PUNCHLIST CONNECTIONS LLC
SUNSET VILLAGE FILING 4 - DRAINAGE
EL PASO COUNTY, COLORADO
CONSTRUCTION DRAWINGS
POND 2

PUNCHLIST CONNECTIONS LLC
SUNSET VILLAGE FILING 4 - DRAINAGE
EL PASO COUNTY, COLORADO 80919
CONSTRUCTION DRAWINGS
POND 2

PERMANENT CONTROL MEASURE
INFRASTRUCTURE DETAILS

PCD FILE NO.: CDR-218

DR.	RDL	CH.	RDL
P.M.	RDL		
JOB	21004166		
SHEET NO.	18

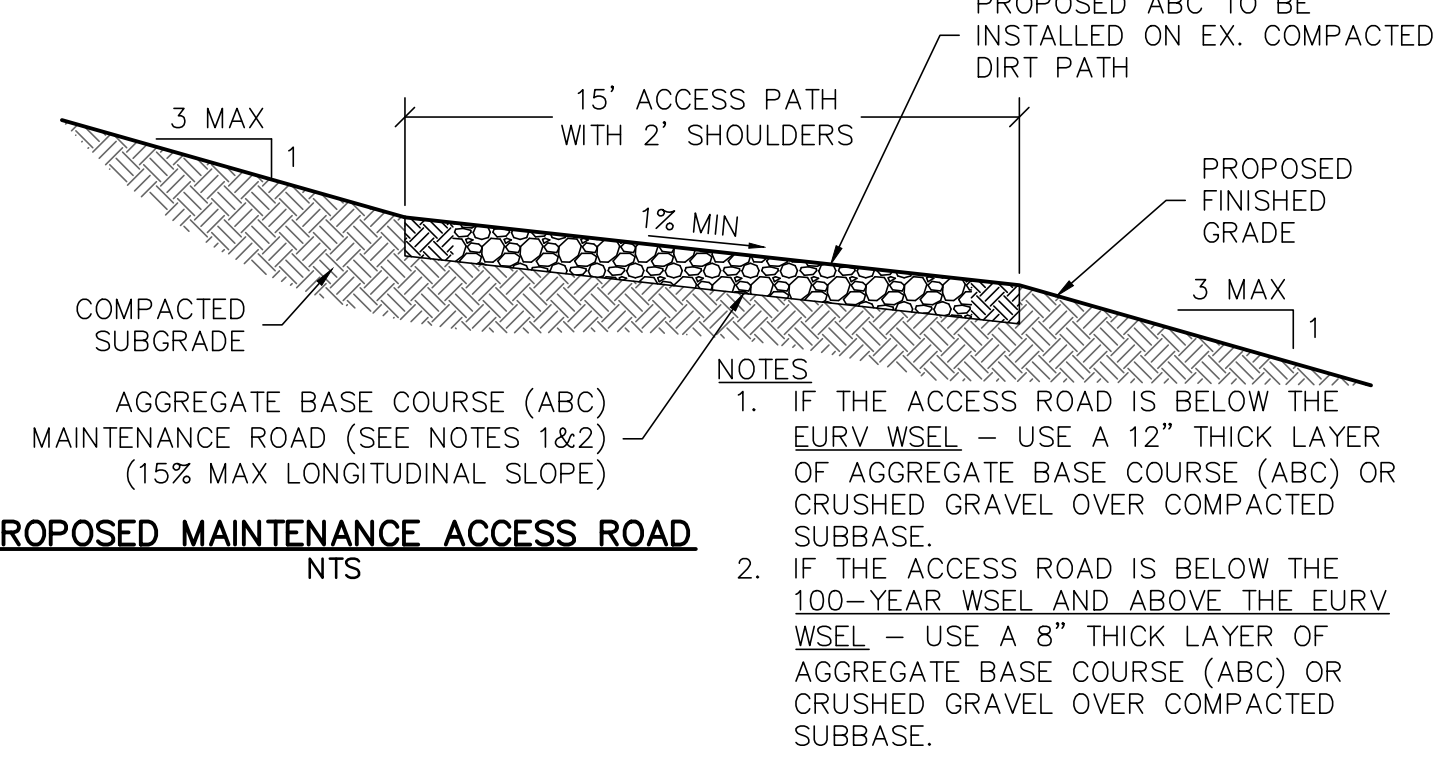
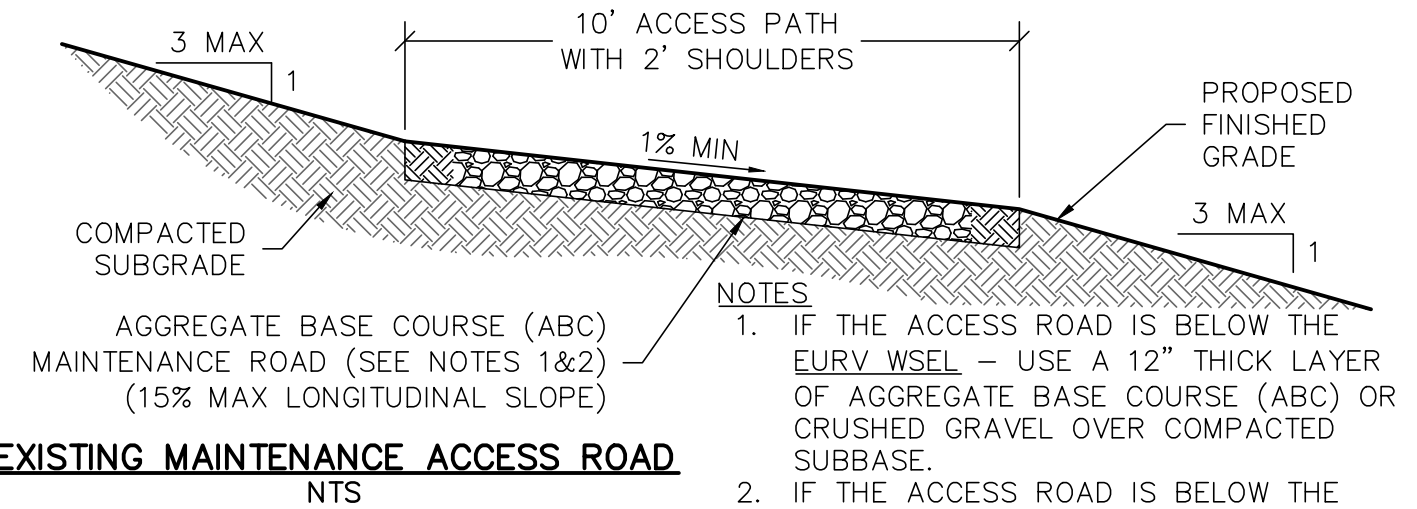
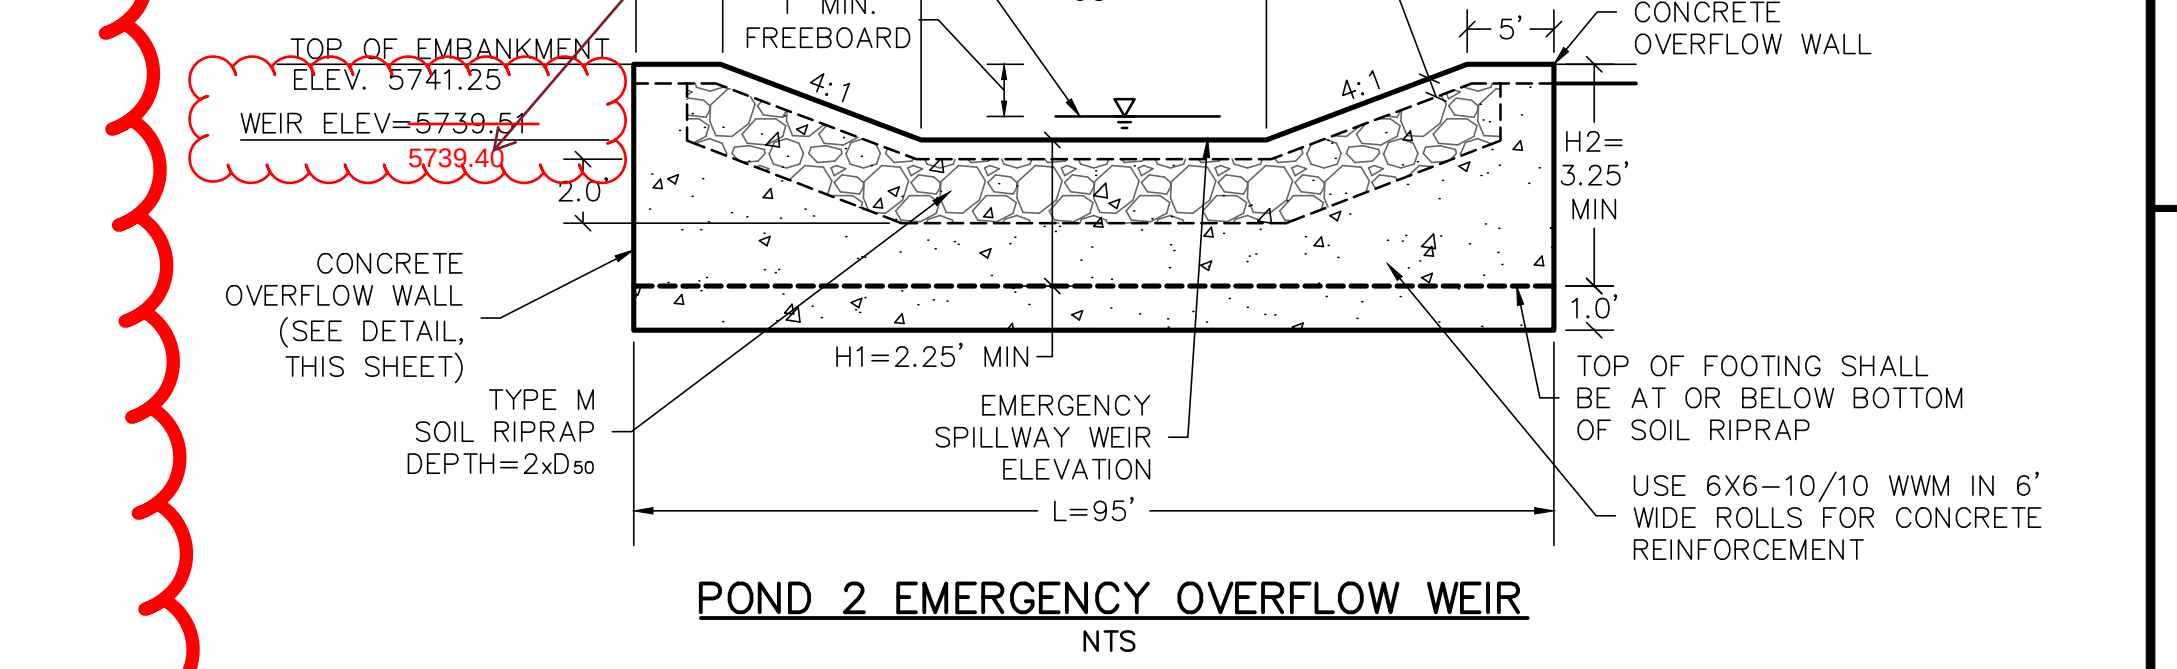
So you want soil riprap on one side of the cutoff wall and buried riprap on the other side? Please confirm, 99% of contractors will miss this nuance, better to just make them the same. If you revise one of these callouts, be sure to check/revise all other plans/details to make sure they are consistent with your choice.

Agreed, we have revised to remain consistent on both sides.
